Item ID: D206-781-061 Accept *N900040100* Setup Start *NS1*
 Revision ID: Stop *NS2*
 Item Name: Baggage Compartment Protector - Floor And Wall
 Start Date: 12/19/2016 Start Qty: 5.00 *5* Cust Item ID:
 Required Date: 12/22/2016 Req'd Qty: 5.00 *5* Customer:
 Reference:

DART SERVICE INSTRUCTION

TO AMEND INSTALLATION INSTRUCTIONS IIN-D407-781-2 REV. A OR LATER APPROVED REVISION
AND INSTRUCTIONS FOR CONTINUED AIRWORTHINESS ICA-D407-781 REV. 3 OR LATER REVISION

A	NEW ISSUE		13.04.08
REV.	DESCRIPTION	BY	DATE
DESIGN			
DRAWN			
CHECKED			
MFG. APPR.	N/A		
APPROVED			
DE APPR.			
DATE	13.04.08		
DART AEROSPACE LTD HAWKESBURY, ONTARIO, CANADA		REV. A SHEET 1 OF 2	
DRAWING NO. DSI 9649		SCALE NTS	
TITLE ALTERNATE INSTALL			
COPYRIGHT © 2013 BY DART AEROSPACE LTD. THIS DOCUMENT IS PRIVATE AND CONFIDENTIAL AND IS SUPPLIED ON THE EXPRESS CONDITION THAT IT IS NOT TO BE USED FOR ANY PURPOSE OR COPIED OR COMMUNICATED TO ANY OTHER PERSON WITHOUT WRITTEN PERMISSION FROM DART AEROSPACE LTD.

**FIGURE 1 - D3879-1 BAGGAGE COMPARTMENT WALL
PROTECTOR - ALTERNATE INSTALLATION**

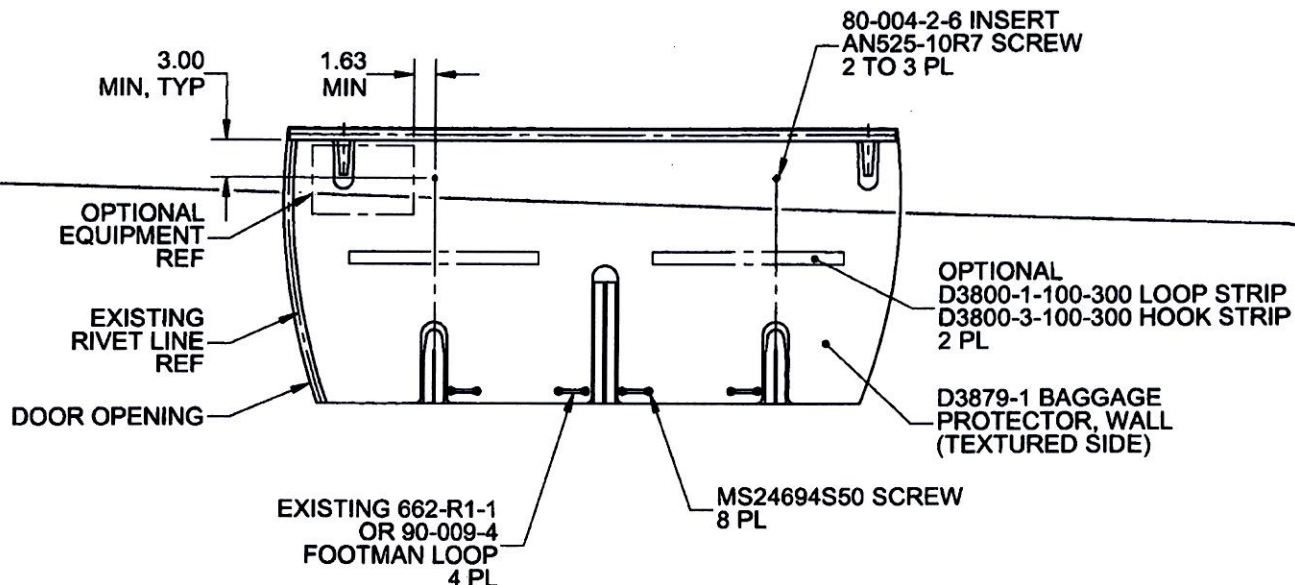
In some aircraft, the top portion of the D206-781-041 Baggage Compartment Wall Protector Kit cannot be installed as indicated in IIN-D407-781-2. The purpose of this DSI is to provide an alternate mounting method to fasten the top portion of the D206-781-041 Baggage Compartment Wall Protector Kit.

It is acceptable to replace qty(2) D3930-1 Clips with qty(2) 80-004-2-6 Inserts. Locate and mark location of the two attachment holes on the baggage compartment wall as shown in Figure 1 of this service instruction. Install 80-004-2-6 Inserts at the marked locations in accordance with Section 3-2-12 of BHT-206-SRM-1. It is acceptable to trim the wall protectors to accommodate optional equipment or transfer attachment holes to the wall protector and install the optional equipment on top of the wall protector with longer fasteners.

Amend the D206-781-041 Baggage Compartment Wall Protector Kit parts list as follows:

Qty -061	Qty -031	Qty -041	Part Number	Description
X			D206-781-061	BAGGAGE COMPARTMENT PROTECTOR KIT (FLOOR AND WALL)
1	X		D206-781-031	BAGGAGE COMPARTMENT FLOOR PROTECTOR KIT
1		X	D206-781-041	BAGGAGE COMPARTMENT WALL PROTECTOR KIT
		2	AN525-10R7	SCREW
		2	80-004-2-6	INSERT
